10 GEV CORNELL SYNCHROTRON LABORATORY

POWER - CONTROL BUILDING LEVELS 4, 5, & 6 PLAN

RELEASED: T. H. Clem
APPROVED: LAB NUCLEAR STUDIES
SHEET 89 OF 102
DRAWING NO. E15
DATE NOV 18 1965
MP-BUSINESS — DATE JAN 15, 1966
WMB & A NO. 111-5

PLAN VIEW
LEVEL 6
SCALE: 1"/8 = 1'-0"

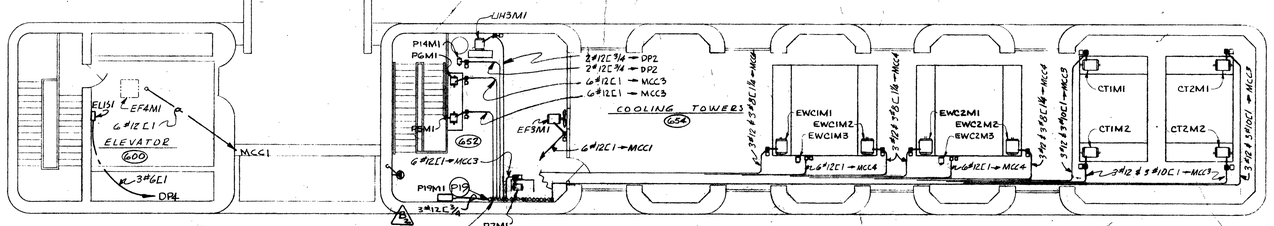
PI9M1 LEFT TO RIGHT
EL1S1
EF4M1
P5M1
P6M1
PI4M1
UH3M1
P7M1
EF5M1
EWC1M1
EWC1M3
EWC1M2
EWC2M1
EWC2M3
EWC2M2
CT1M1
CT1M2
CT2M2
CT2M1.

LTR	REVISIONS	DATE	BY	CHK'D	APP'D	APP'D
C	AS BUILT CORRECTION	6/14/67	RDL			
B	1) PP9 & PP10 FEEDERS WERE 4# 2/0 MAINS WERE 3A/225/125/1500, SURFACE MTG. 2) ADDED PI9M1 3) WAS 8 SPACES LEV. 5 4) WAS 6 SPACES LEV. 4 5) WAS 16 SPACES @ 6"O.C. = 8'0" 6) BUS TIES WERE 3#350KCMC 7) T1 & T2 SECONDARIES WERE 3#350MCM C3 8) T2 PRIMARY WAS 6#4C3 9) DELETE NOTE #1 10) ADDED NOTE #6	5-23-66	3-Fd			
A	SEE ADDENDUM 1	6-3-66	GMS JVG	WMB	T.CLINE

GROUND ROD DETAIL
SCALE: 1"/2 = 1'-0"

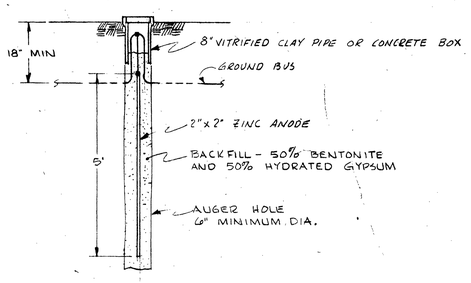
C SECTION DELETED
